# CITY OF SACRAMENTO

- SUBJECT:
1. Environmental Determination
  2. Tentative Map (P85-456)

LOCATION: Southwest corner of Mack Road and Morrison Creek

**APPLICANT** Morton & Pitalo, Inc., 1430 Alhambra Boulevard, Sacramento, CA 95816  
**OWNER** Franklin Triangle, Ltd., 5855 Auburn Boulevard, Sacramento, CA 95841  
**PLANS BY** Morton & Pitalo, Inc., 1430 Alhambra Boulevard, Sacramento, CA 95816  
**FILING DATE** 11-4-85 **ENVIR. DET.** 11-8-85 **REPORT BY** FG:sg  
**ASSESSOR'S-PCL. NO.** 119-007-31

# EXHIBIT A SITE PLAN

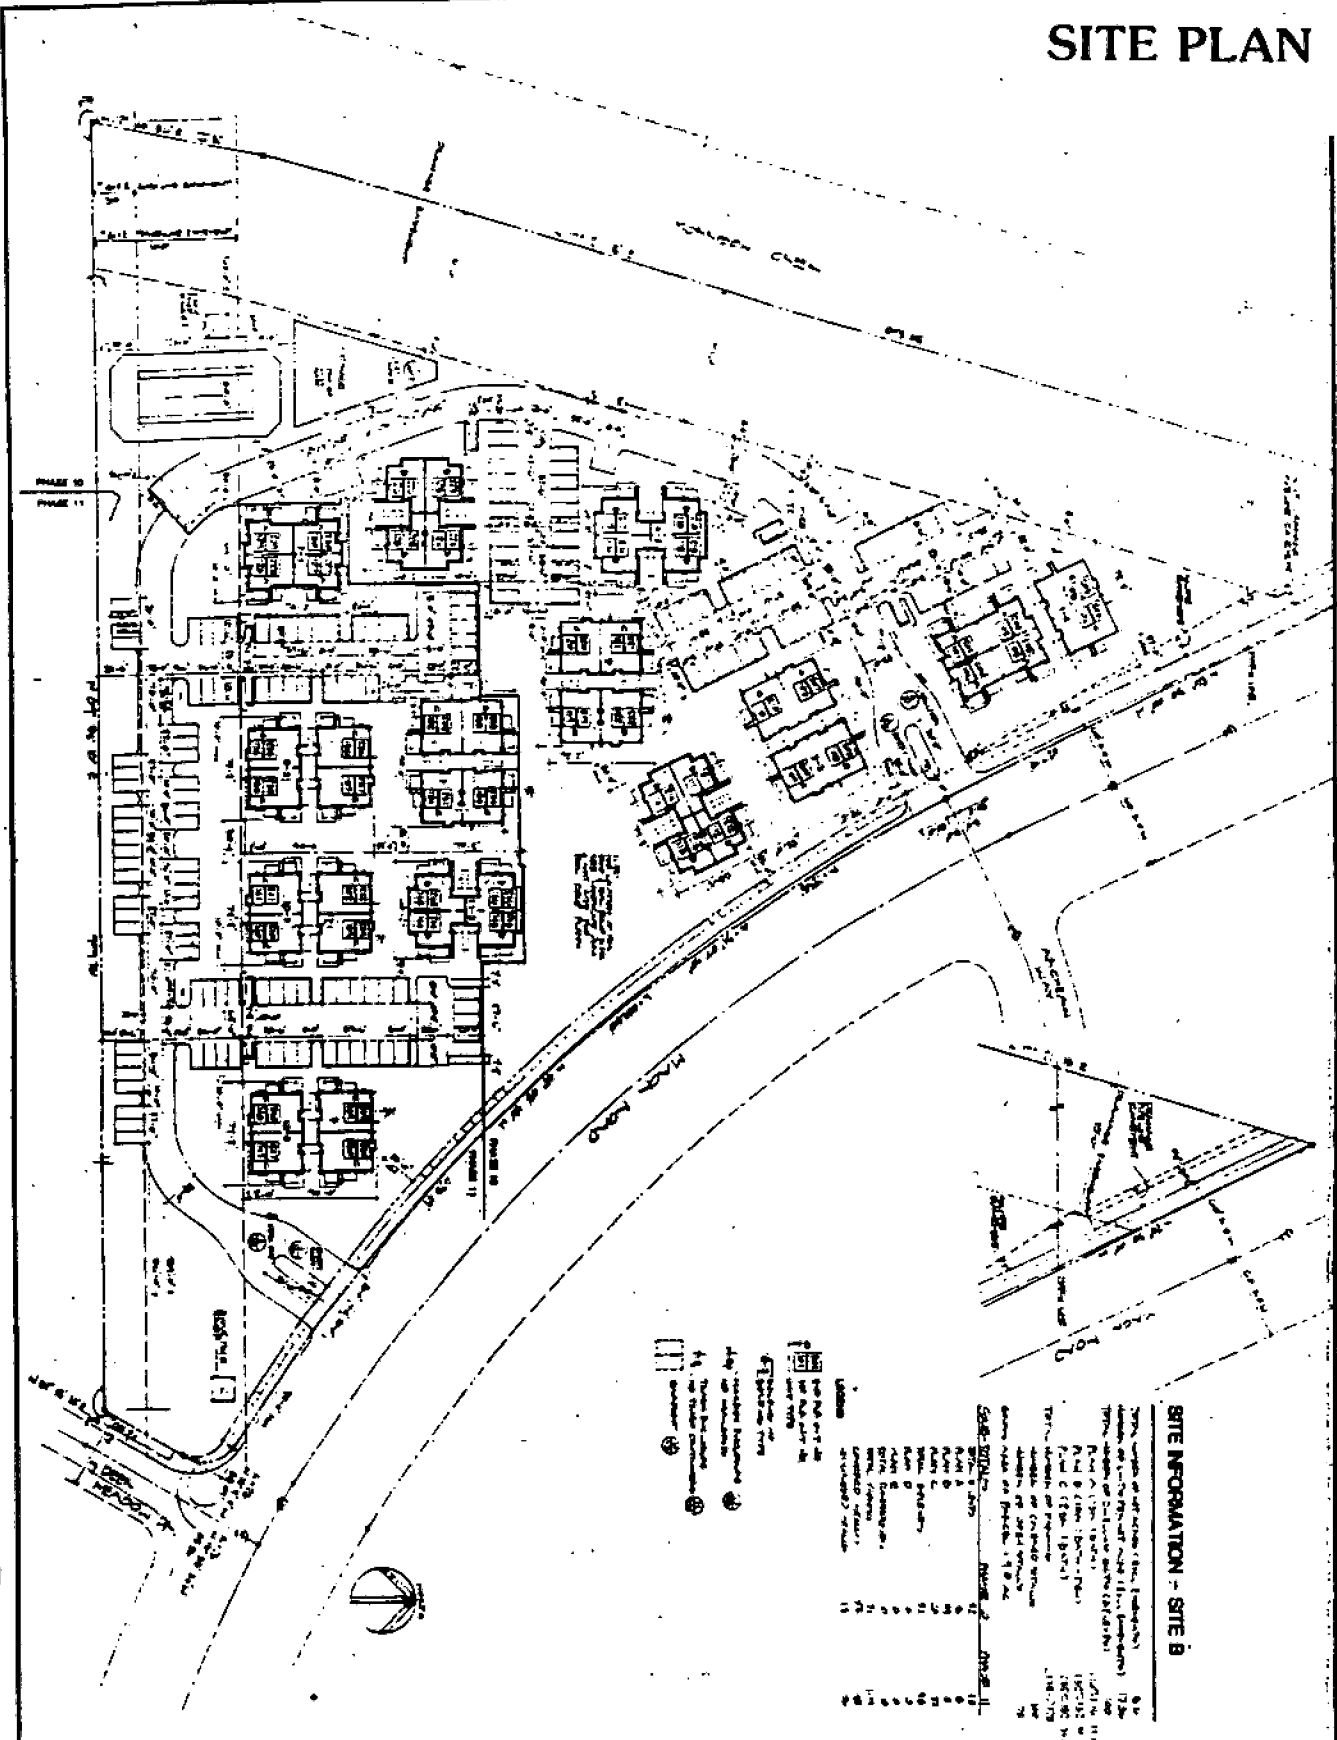
- B. The applicant is proposing a one lot subdivision and 100 airspace condominium units to be developed in two phases. A total of 48 one bedroom and 52 two bedroom units ranging in size from 759-1,010 square feet will be constructed. The proposed site plan shows a cluster of 12 buildings of two stories in height. The site is constrained by a 95 foot drainage easement along the west property line and a 100 foot powerline easement along the south property line.
- C. The exterior building materials for the units will include stucco/wood siding and composition shingle roofs. Staff feels that the building design provides good architectural relief on both the front and end elevations.

Some of the carport structures would face onto Mack Road. Staff recommends that the carport be designed so as to be compatible in design and materials with the main building. The applicant must submit elevations of the carports for review and approval prior to issuance of building permits. A six foot high solid masonry block wall should be constructed along the south property line as a buffer between the single family residences to the south and the parking area and tennis courts.

- D. No bicycle parking is shown on the site plan. Staff recommends that the applicant provide one bicycle parking facility for every 10 parking spaces as required by the Zoning Ordinance. A revised site plan indicating the bicycle parking areas shall be submitted for review and approval prior to issuance of building permits.

- F. Other site amenities include a tennis court, pool and pond (pool and pond not shown on site plan). A common storage area is also indicated for homeowners' use. The applicant should also provide a clubhouse adjacent to the pool area. The clubhouse design shall be compatible with residential structures and shall be reviewed and approved by staff.

3. The applicant shall provide on-site bicycle parking spaces. A revised site plan indicating the bicycle parking areas shall be submitted for staff review and approval prior to issuance of building permits.

4. Trash enclosures shall be provided in sufficient number and in a convenient location. Additional trash enclosures shall be located on-site and a revised site plan shall indicate the additional enclosures.

5. A six foot high solid decorative masonry block wall shall be constructed along the south property line. Design of the wall shall be reviewed and approved by the Planning Director.

6. The applicant shall submit elevations of the carport structure. Carports shall be trimmed with a material which is compatible with the proposed condominium units.
